REMARKS

The present application includes pending claims 1-19. By this Amendment, claims 1-3, 7, 13-14, and 19 have been amended. It is respectfully submitted that the pending claims define allowable subject matter.

FIG. 2

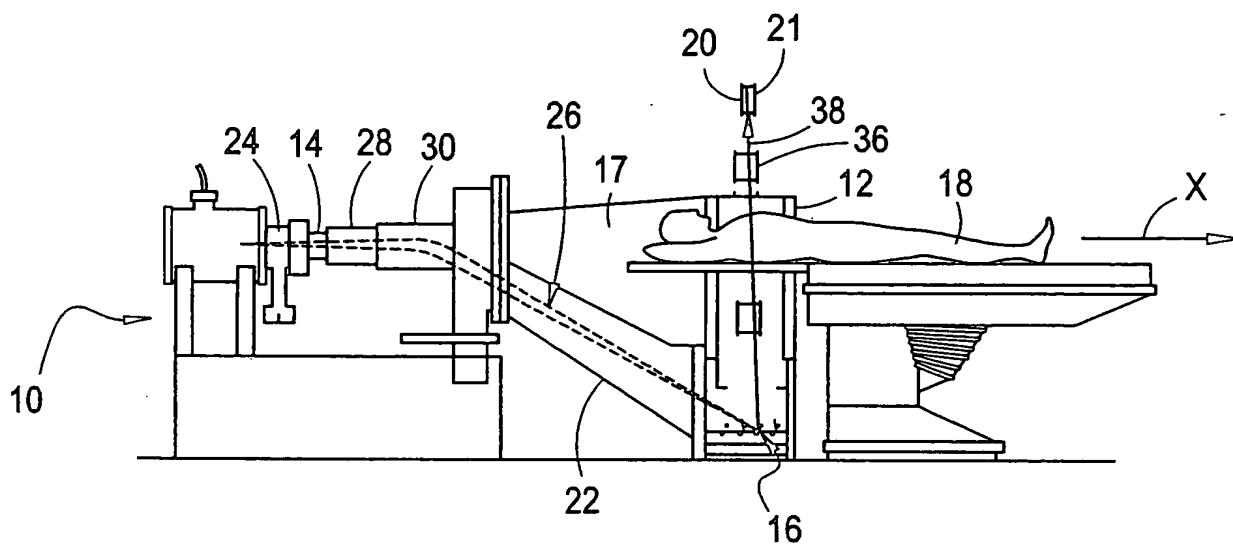
The drawings were objected to because reference character “18” was used to designate two different objects in Figures 1 and 2. The Applicant has attached a “Replacement Sheet” of amended drawings. The drawings have been amended to show that reference numeral 18 in Figure 2 refers to the patient, just as in Figure 1.

The drawings were also objected to because Figure 2 includes “OR” and “SOR.” The Applicants submit that “OR” refers to “Overlap Region,” while “SOR” refers to “Source Only Region.” Nevertheless, the Applicant has amended Figure 2 to delete “OR” and “SOR” to avoid any confusion.
